From: Scott Castle <[REDACTED]>
Sent: 20 September 2019 12:00
To: Carol Reynolds <[REDACTED]>
Cc: Anita Gardner <[REDACTED]>; [REDACTED]; Sue Shelley
<[REDACTED]>
Subject: RE: 22 Beach Road, Littlehampton.
Importance: High

From: Scott Castle <[REDACTED]>
Sent: 23 August 2019 16:19
To: Carol Reynolds <[REDACTED]>
Cc: Darren Godfrey <[REDACTED]>
Subject: 22 Beach Road, Littlehampton.
Importance: High

I write further to the client providing me with your feedback on the AASL acoustic report dated 6th June 2019 for the above site.

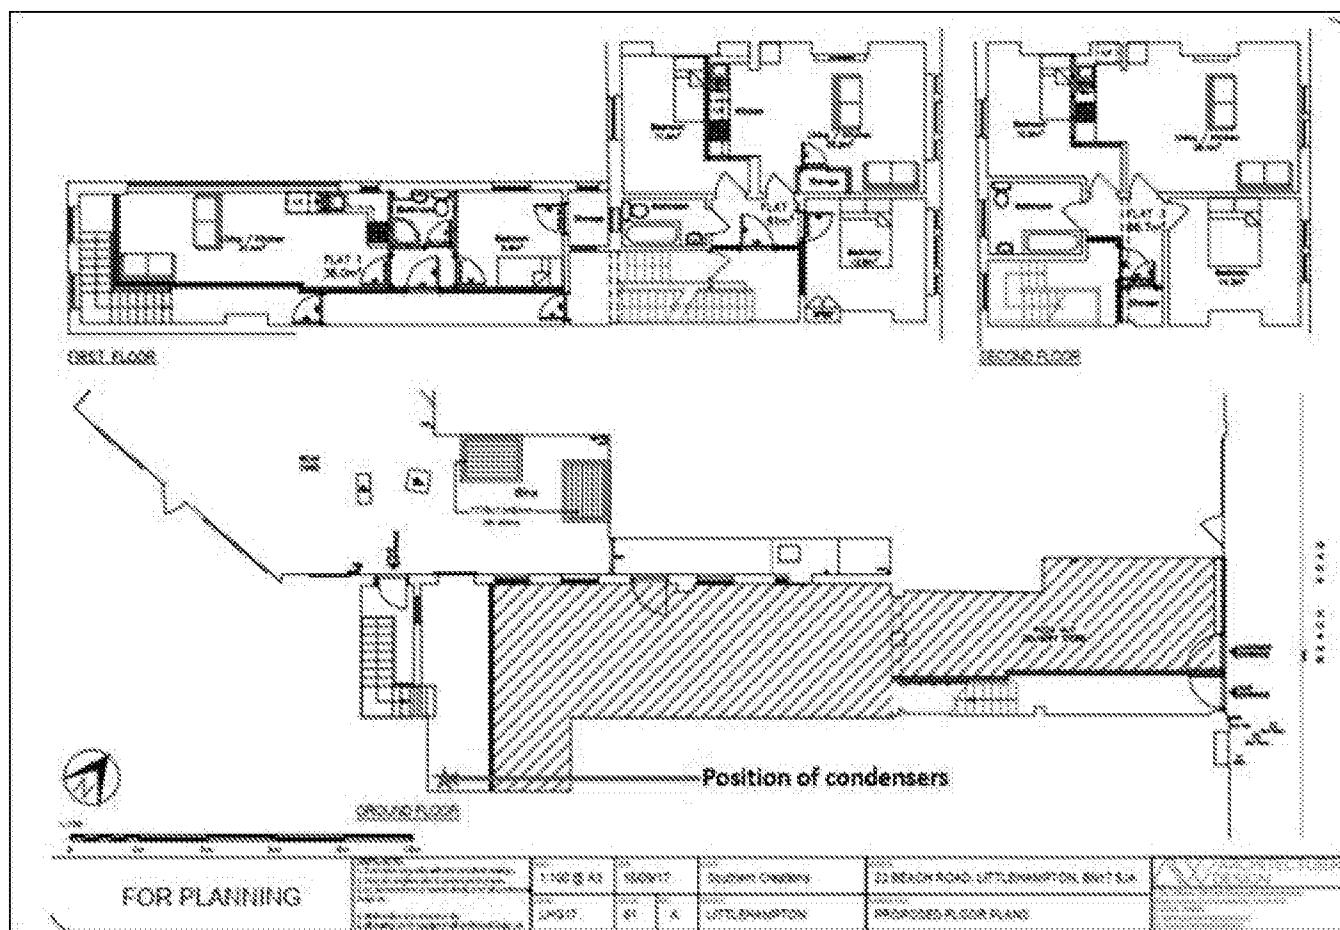
Having studied the online comments and the overall recommendation not to discharge the condition, I have the following points to make and if you are happy, these can be inserted into the report and the report reissued accordingly.

1. The condenser unit for the Walk in chiller.

The condensers were previously located below the bedroom window but have since been relocated to inside the rear garage unit at the very rear of Flat 1, outside the demise of the flat.

The condensers are mounted on anti-vibration mounts on the ground floor. Both the garage and the pizza hut ceiling were soundproofed at the same time. The condenser positions inside the garage void are shown below.

The condensers would have run as part of the survey and are contained with the survey data.
